Agenda item title: TP-2021-200

Agenda item title: * Ministerial Planning Referral:ID-2021-4 Agenda Item 6.2

City of Melbourne, Council Meeting Room, Melbourne Town Hall Administration Building
01 Feb 2022, 5.30pm – Meeting No.27
Agenda Item FMC 6.2 Ministerial Planning Referral: ID-2021-4, Amendment C365: Melbourne Arts Precinct Transformation Masterplan

6.3 Ministerial Planning Referral: TPRM-2021-11, 204-208, 212, 226, 230 and 232 King Street, Melbourne Part 1 of 2

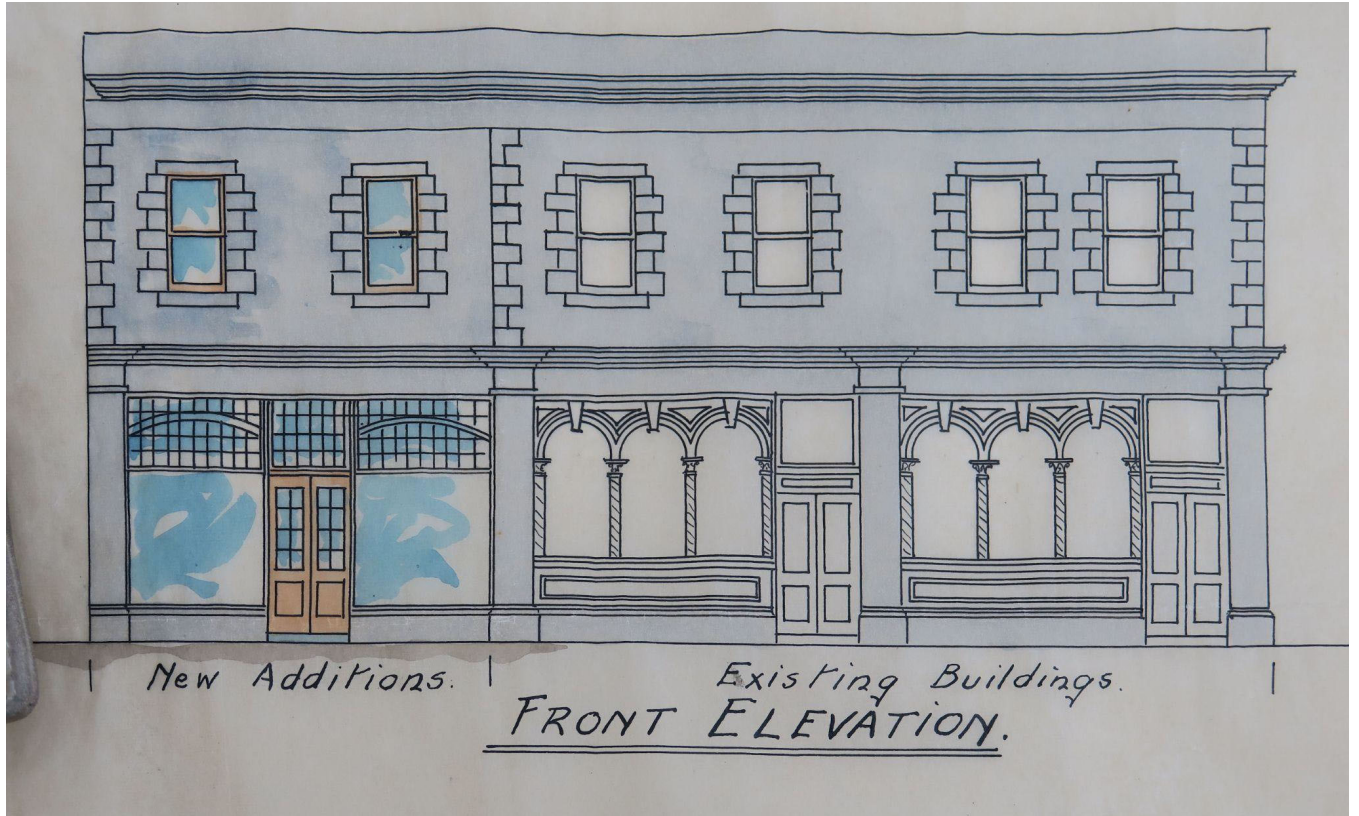
We are happy to see plans to retain both the facades of the Greater Western Hotel and Tramway House on the other end despite a lack of current heritage listing. It is also great to see the pub will actually retain its function as a pub post-development, something sadly lacking in many recent pub redevelopments in the CBD. The use of masonry in Brown Alley is also great, though we have to note this does involve the destruction of an entire brick lanescape with unique hook pattern, which will be turned into a straight line, yet another unique laneway pattern sadly made generic

This is an issue of the City of Melbourne not protecting many historic laneway facades where the main street facades are less intact, where we believe laneway sides should be looked at the same as main street heritage. It is commendable that the developers are retaining and partially restoring facades that haven't yet been heritage listed. We do note though its also disappointing that the City of Melbourne's heritage guidelines regarding setbacks can't be applied here, as the Greater Western Hotel is certainly deserving of a 'significant' heritage status in the planning scheme.

Ideally we would like to see more retention of the sides and backs of both buildings being retained, especially the original bluestone rear and brick chimneys of the Hotel. The new scheme is also a vast improvement on originally approved plans, though we would also ideally hope for more setback or recess of the tower from the Greater Western Hotel

One suggestion which could easily be incorporated is to restore, or at least re-create a similar ground floor as evidenced by 1920's images found below, as opposed to the current ground floor openings or the proposed new openings, neither of which are historically accurate. This would provide both historical context and even more ground activation/transparency to the facade, which we would assume are a net positive for the developers.
